WHATCOM COUNTY HEALTH DEPARTMENT
**ON-SITE SEWAGE SYSTEM
CONSTRUCTION PERMIT**

Site Address 14039 Chimney Lane

WHATCOM COUNTY HEALTH DEPARTMENT
**ON-SITE SEWAGE SYSTEM
PERMIT APPLICATION**

WHATCOM COUNTY HEALTH DEPARTMENT
FILE NOTES

TAX PARCEL:390708 398457
SCALE 1"=30'
2 BEDROOM
PROPERTY LINES AS GIVEN BY
OWNER

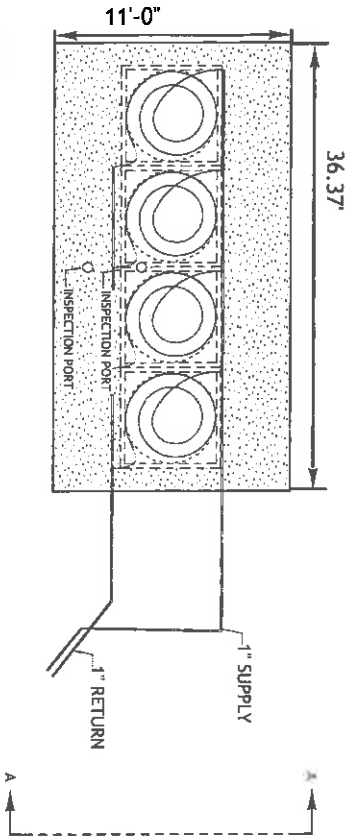
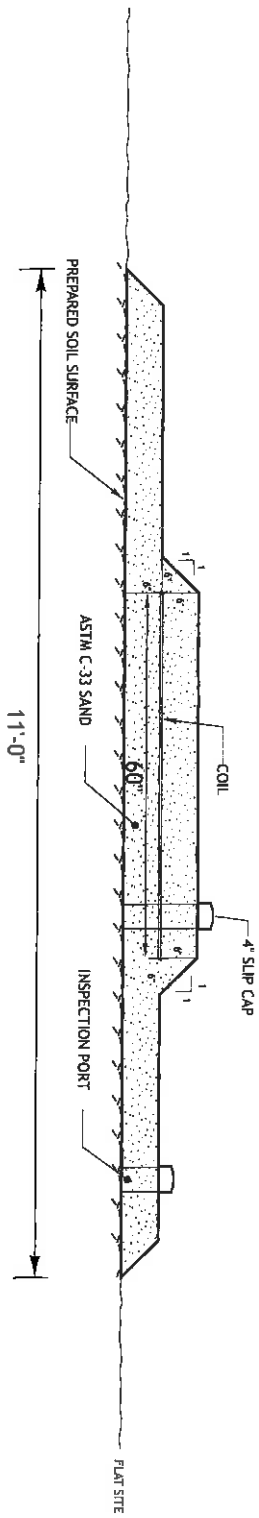
Permit	Observed
DF Size	11x36	✓
DF Location	10' from NW prop line 25' from SW prop line	✓ 42' NW of corner to H2O meter ✓
Soils/soil depth	SL-1 0-14 Brown loam 14-30 sandy loam w/ gravel SL-2 0-12 brown loam 12-31 sandy loam w/ some gravel	0-30 sandy loam color change @ 24" saturation @ 24" 0-30 sandy loam color Δ @ 28" saturation @ 28"
Slope	0%	
Water	Public	
Set Backs Property Lines Water Ditches Foundations	10' to NW prop line 25' to SW prop line	✓✓
OSS?	NO	
Property Lines?
